# Access Compliance Report

## Public Rights-of-Way

Intersection ID: 10020667	Main Street: BEACON_VALLEY_ST	Cross Street: N/A	Location: NW
ADA ID: 5DE5F01441E1	Ramp Type: Perpendicular Diagonal	Initial Pass/Fail: Fail	Overall Compliance: No
			Severity Score: 33.75

#### Codes/Mitigation Info/Possible Solution

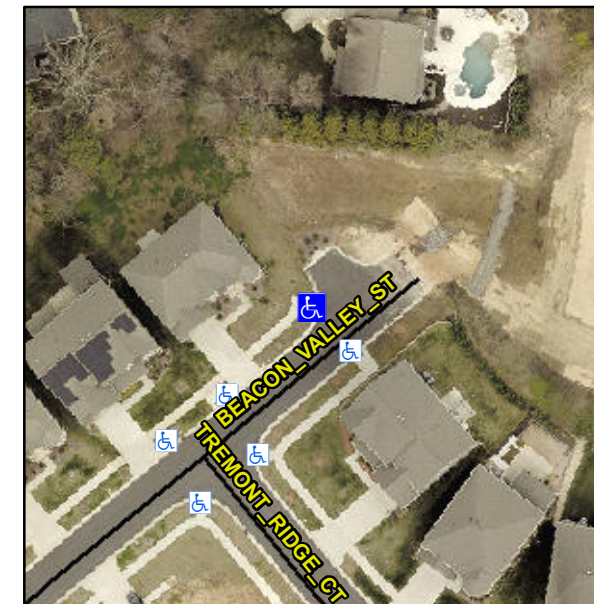
**Not Found, R304.5.1, R304.5.3**

Compliance	Description	Data	Compliance	Description	Data
N/A	Ramp Length (in)	96.0	Yes	Ramp Slope (%)	5.2
No	Ramp Width (in)	46.0	No	Ramp XSlope (%)	7.4
N/A	Flare Type LT	N/A	N/A	Flare Type RT	N/A
N/A	Flare Slope LT (%)	N/A	N/A	Flare Slope RT (%)	N/A
N/A	Flare Traversable LT?	N/A	N/A	Flare Traversable RT?	N/A
N/A	Landing Length (in)	N/A	N/A	DWS Provided?	N/A
N/A	Landing Width (in)	N/A	N/A	DWS Contrast?	N/A
N/A	Landing Slope (%)	N/A	N/A	DWS Length (in)	N/A
N/A	Landing X Slope (%)	N/A	N/A	DWS Full Width?	N/A
N/A	Landing Curb? (Y/N)	N/A	N/A	DWS Offset (in)	N/A
N/A	Shared Landing?	N/A			
N/A	Gutter Ponding?	N/A	N/A	Gutter Slope (%)	N/A
N/A	Gutter Lip Ht (in)	3.0	N/A	Gutter X Slope (%)	N/A
N/A	Painted X Walk1?	No	N/A	Painted X Walk2?	No
	X Walk 1 Direction	To SW		X Walk 2 Direction	To SE
N/A	X Walk 1 Width (in)	N/A	N/A	X Walk 2 Width (in)	N/A
	X Walk 1 Slope (%)	0.7		X Walk 2 Slope (%)	7.1
	X Walk 1 X Slope (%)	6.3		X Walk 2 X Slope (%)	1.4

**Remove & Replace Curb Ramp With Two New Directional Ramps or Equivalent.**
